**RESPONSES TO NUCLEAR REGULATORY COMMISSION
MAY 8, 2015, REQUEST FOR ADDITIONAL INFORMATION FOR
ENVIRONMENTAL REVIEW OF LICENSE AMENDMENT REQUEST FOR
JEFFERSON PROVING GROUND DEPLETED URANIUM IMPACT AREA
LICENSE TERMINATION, MATERIALS LICENSE SUB-1435**

U.S. ARMY
FINAL
JEFFERSON
PROVING GROUND

6 July 2015

Figure 1. Jefferson Proving Ground Simulated Groundwater Elevation for Overburden Layer

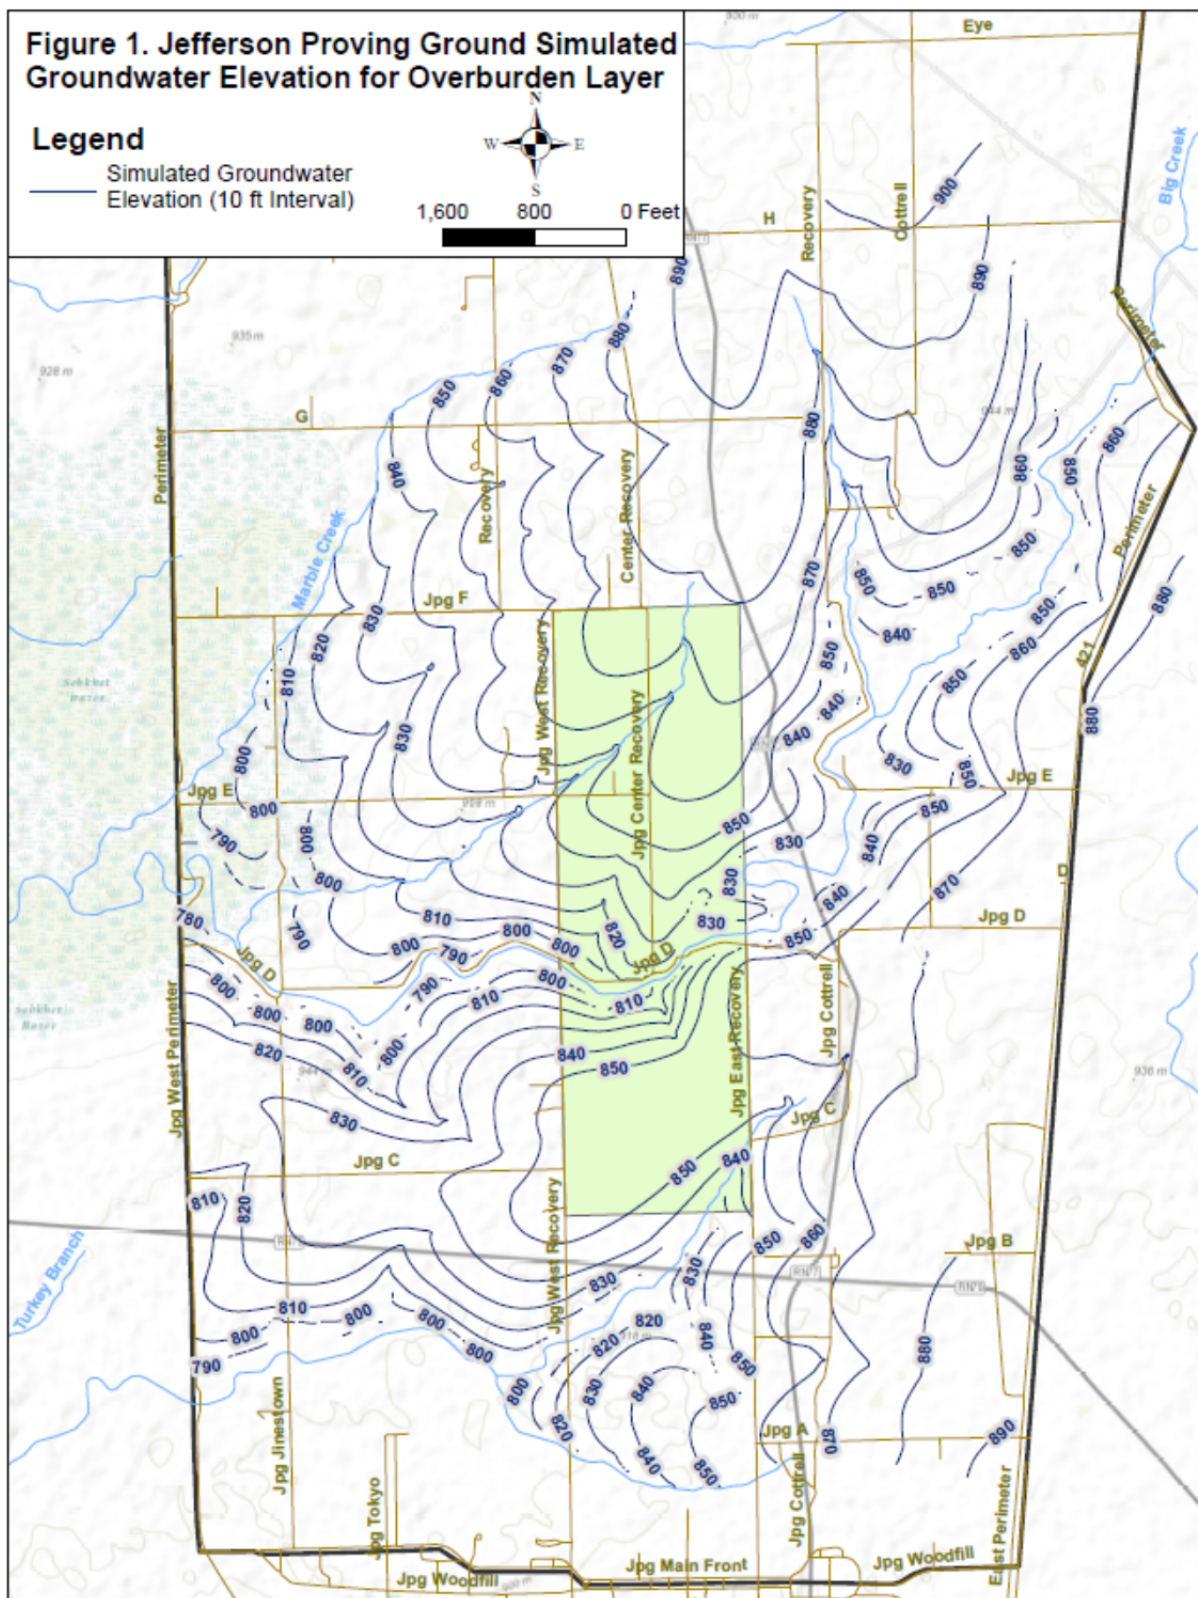
Provide the results of simulated water balances and simulated groundwater elevation contours produced by the calibrated groundwater flow model (MODFLOW-SURFACT) described in Section 5 (Groundwater Flow Model) in Appendix B (Groundwater Modeling) of the ER (U.S. Army, 2013a). In addition, provide annotated input files for the calibrated MODFLOW- SURFACT model. The simulated water balance results should include: (i) the simulated flow between the overburden layer (layer 1) and shallow bedrock layer (layer 2) for the entire model domain; (ii) flow to stream segments assigned the river boundary condition within JPG; (iii) flow to stream segments assigned the drain boundary condition within JPG; and (iv) simulated discharge between the overburden layer and the shallow bedrock layer within the footprint of the DU Impact Area. The simulated groundwater elevation contours should include original contour maps of the simulated groundwater elevations in layers 1 and 2 of the model, or electronic files of the simulated groundwater elevations in these layers in the form of geographical coordinates (latitude-longitude, UTM coordinates, or model coordinates).

electronic form (shapefiles). Figures 1 and 2 show 10-foot contoured water levels. The shapefiles include information for the water levels at contour intervals of 5 and 10 feet.
